**Site Plan, 820110140: Anselmo Property**

- A. Site Plan 820110140 Anselmo Property**  
38 dwelling units (including 12.5% MPDUs), at the southern terminus of Rainbow Drive on the north side of Briggs Chaney Road, 42.28 acres, RE-1 Zone, Cloverly Planning Area, Upper Paint Branch Environmental Overlay Zone.

*Staff recommendation: Approval, with conditions*

SITE SOLUTIONS, INC. IMPERVIOUS AREA EXHIBIT

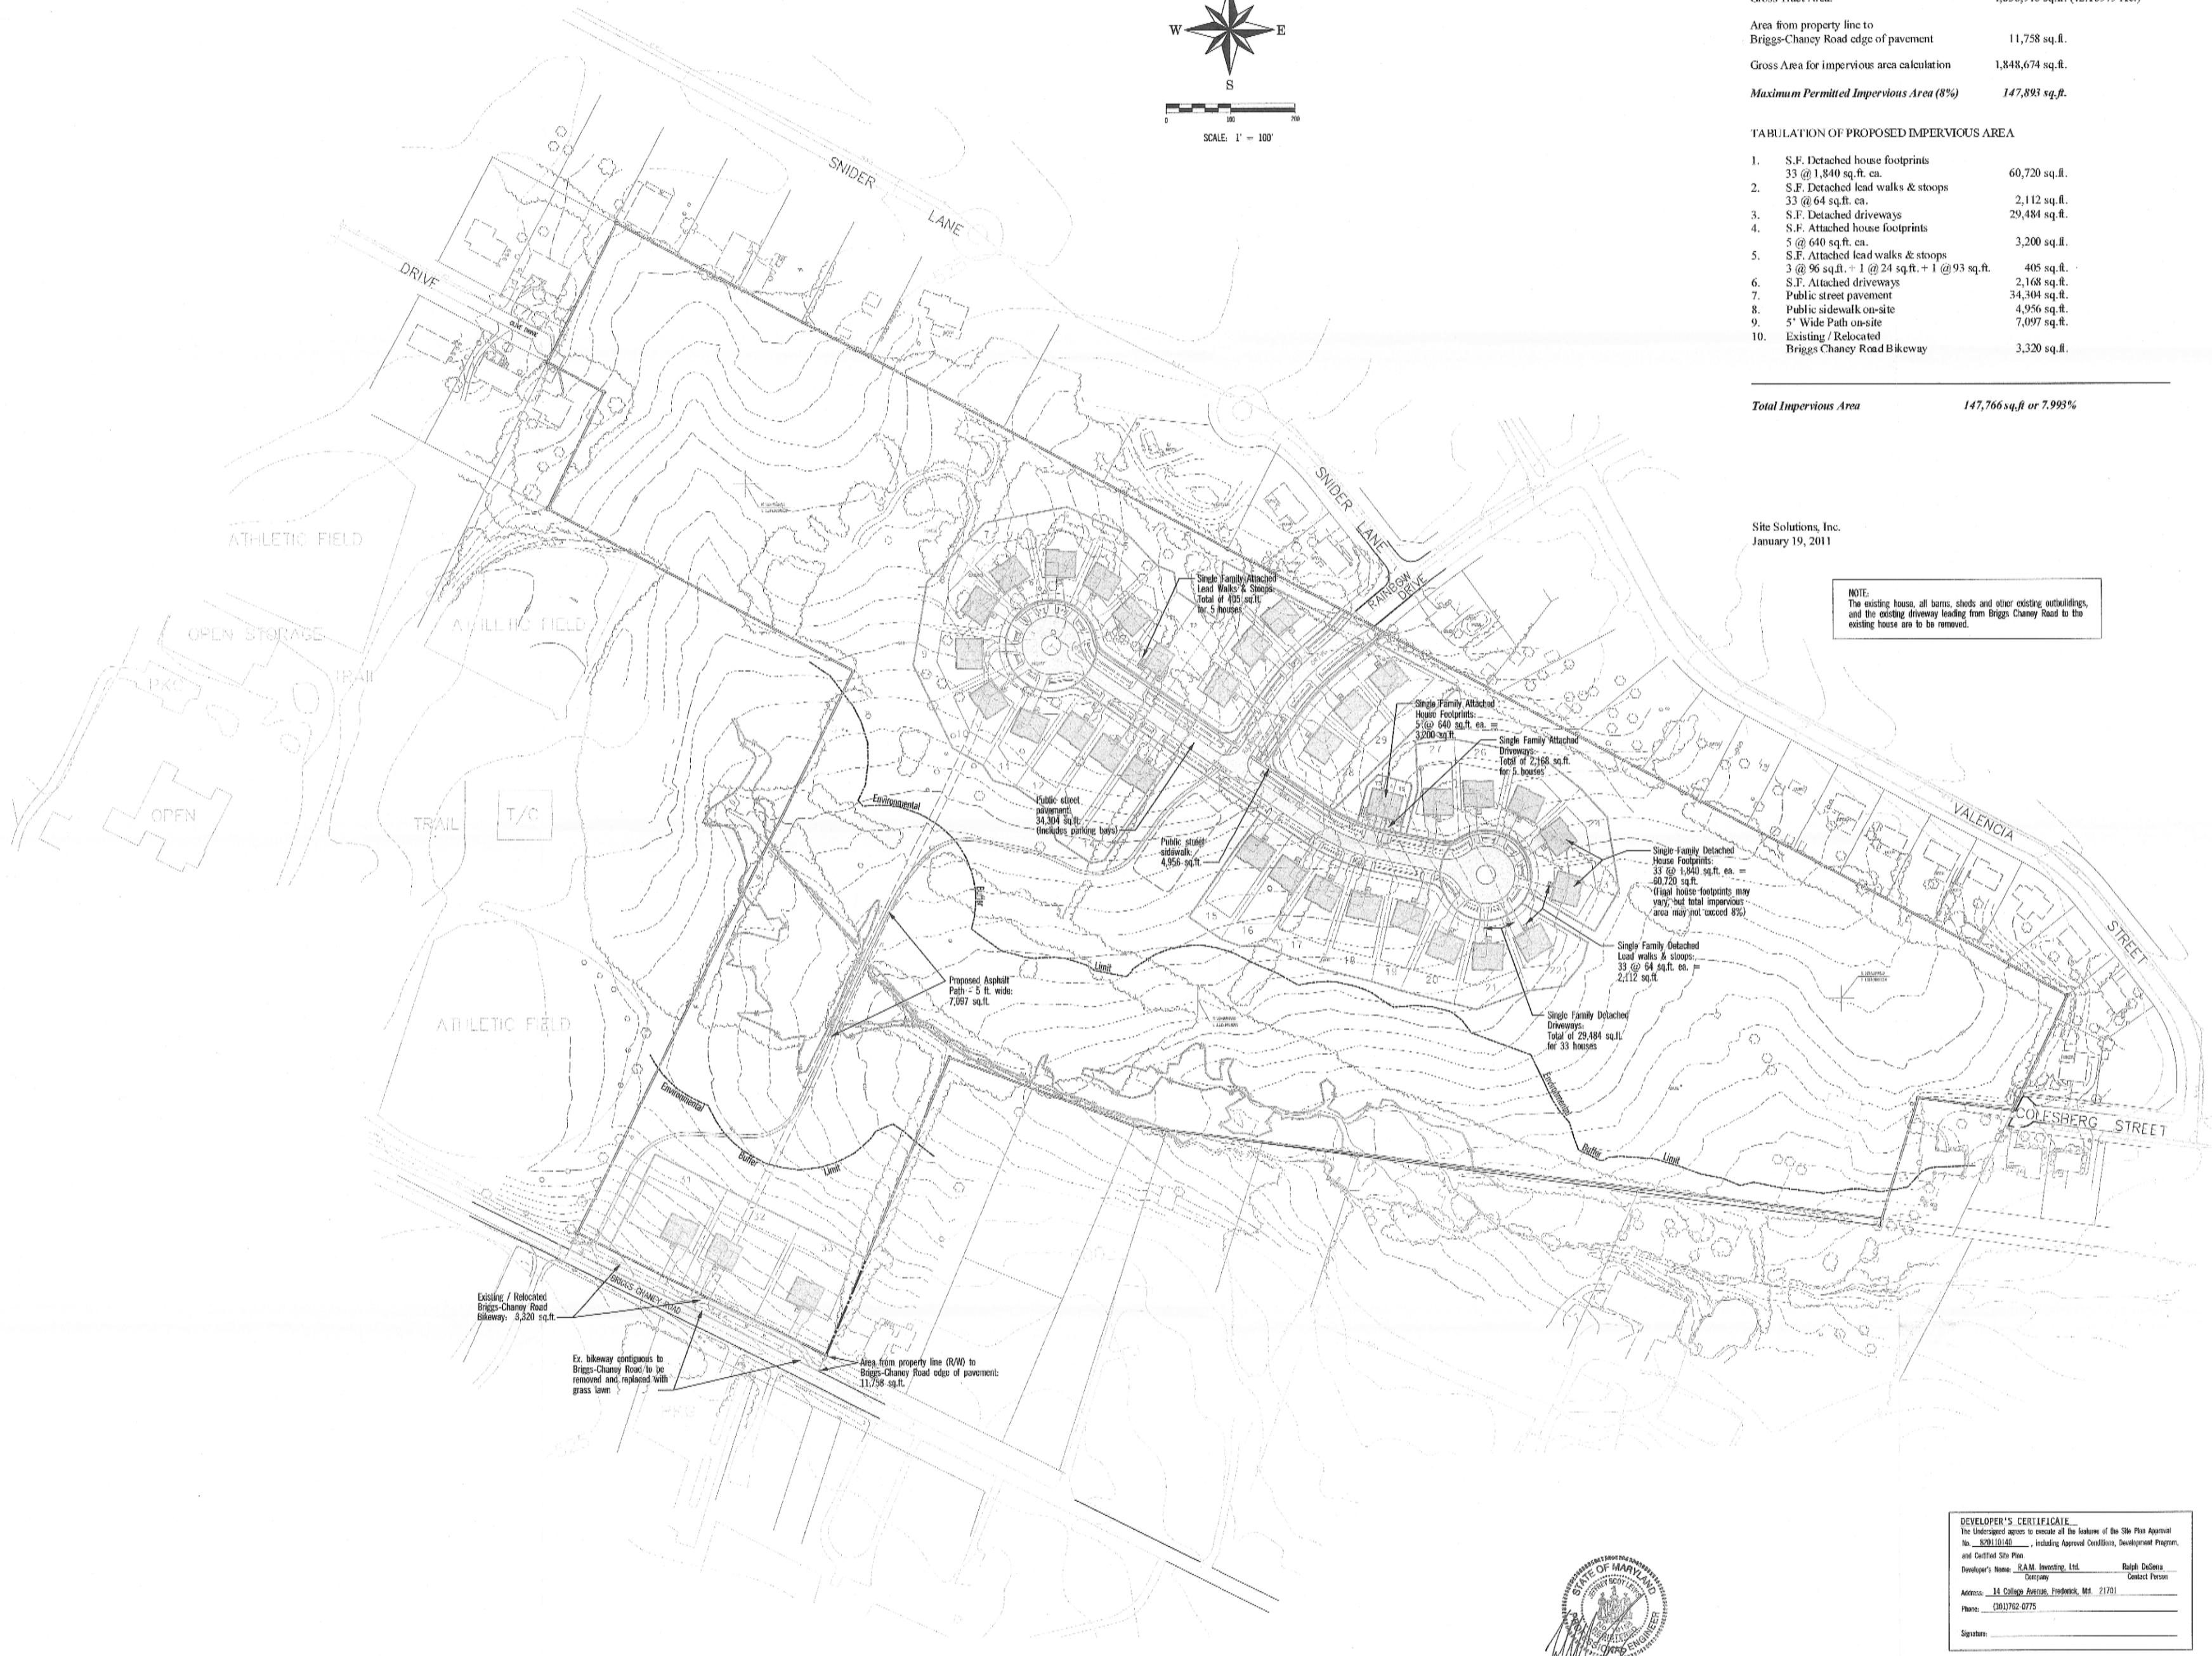
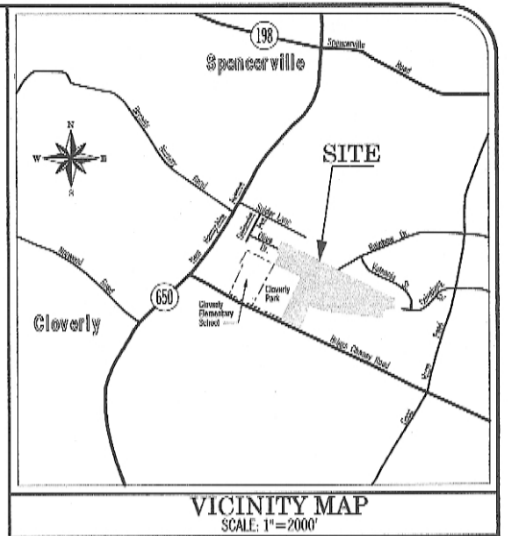
Impervious surface restrictions for development projects in the Upper Paint Branch SPA are set forth in the Environmental Overlay Zone for the Upper Paint Branch SPA (Section 59-C-18.152). The Environmental Overlay Zone has an 8 percent imperviousness limit for new projects or redevelopment projects with current imperviousness at or below 8 percent. The proposed development will result in an imperviousness of 8.0 percent. .

- a) Prior to recording of plat, applicant must enter into an agreement with the Planning Board to limit impervious surfaces to no more than 8.0 percent, which shall include the impervious surfaces in the entire gross tract area, including the property and the land area between the right-of-way/property line and the edge of the pavement of Briggs Chaney Road along the property frontage.
- b) Prior to release of building permit, applicant must demonstrate conformance to the impervious surface limit. Any modifications which increase imperviousness beyond 8.0 percent will require Planning Board approval.
- c) Applicant must conform to the conditions as stated in the Montgomery County Department of Permitting Service (MCDPS) Final Water Quality Plan approval letter dated November 18, 2011, unless otherwise amended.
